UNITED STATES PATENT AND TRADEMARK OFFICE

Office Action Summary	Application No. 10/633,296	Applicant(s) CZYSZ, MICHAEL	
	Examiner Saúl J. Rodríguez	Art Unit 3681

This is a first office action on the merits of patent application S. N. 10/633,296.

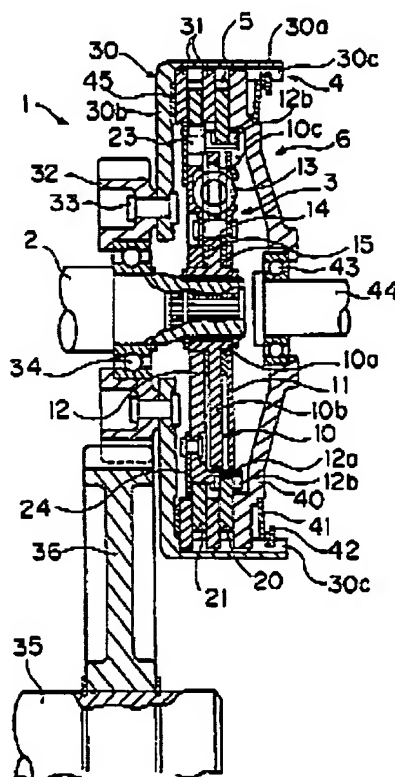
Claim 1 recites a slipper clutch capable of providing a positive coupling. Noting that a sprag clutch is disclosed and claimed, it is unclear how such would provide anything other than a frictional coupling.

Claims 8 and 16 recite engines having a pair of shafts. It is unclear if the output shaft and the primary drive output refer to the output of the gearbox.

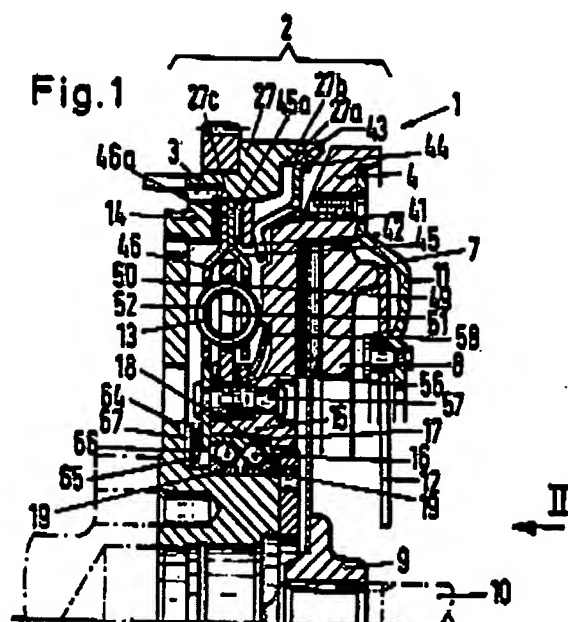
Kajitani et al. discloses a motorcycle comprising a chassis (Col. 1, line 17), an internal combustion engine (Col. 8, line 41), a primary clutch (60,), a positive engagement one-way clutch (68, Fig. 2), a crankshaft (51), a gearbox output shaft (49), a slipper clutch (), a clutch basket (60a), a stack of drive plates (67), a spring (71), an adjustable (Col. 7, 62-65) tensioner (75). Kajitani discloses a mechanically distinguishable slipper clutch, but does not show a remotely placed slipper assembly.

Friedmann, on the other hand, discloses a clutch assembly for a longitudinally mounted engine having a slipper clutch (14) separate from a primary clutch (7).

Then, it would have been obvious to a person of ordinary skill in the art at the time the invention was made to separate the slipper clutch of Kajitani et al. in a remote and separate assembly to isolate the wear of one clutch with respect to the other.
